June 10, 2025
Revised October 14, 2025

SEQRA 22-218 - Sheffield Gardens
NYS Route 17K
Town of Montgomery, Orange County, New York
Colliers Engineering & Design Project No. 22012941A

Proposed Traffic Signal Timings – Weekday PM Peak Hour

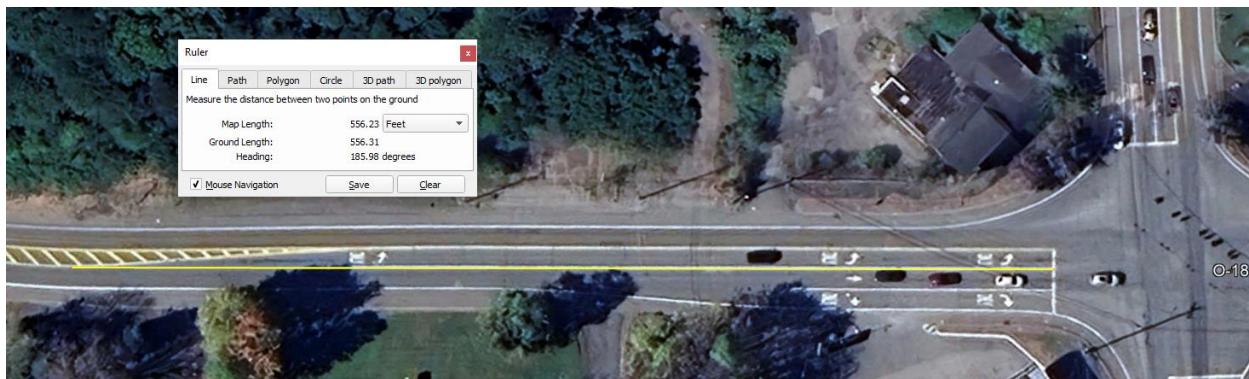
During the PM Peak Hour, the northbound left turn movement is projected to exceed the provided 400-ft. storage length under both the No-Build and Build conditions. Traffic signal timing modifications have been explored to improve the operation of the northbound left turn movement. The traffic signal timing modifications include providing nine (9) seconds of additional green time to the northbound left turn/northbound through movement phases. These modifications will result in an approximately 40 ft. reduction of the northbound left turn queue, but the queue will still exceed the available left turn lane length.

Furthermore, it is noted that while the lane is striped with 400 ft. of storage, when the left turn lane taper area is included, the total storage is approximately 550 ft. This is detailed in the aerial figure below. Based on this the northbound left turn queue will not impact northbound through traffic.
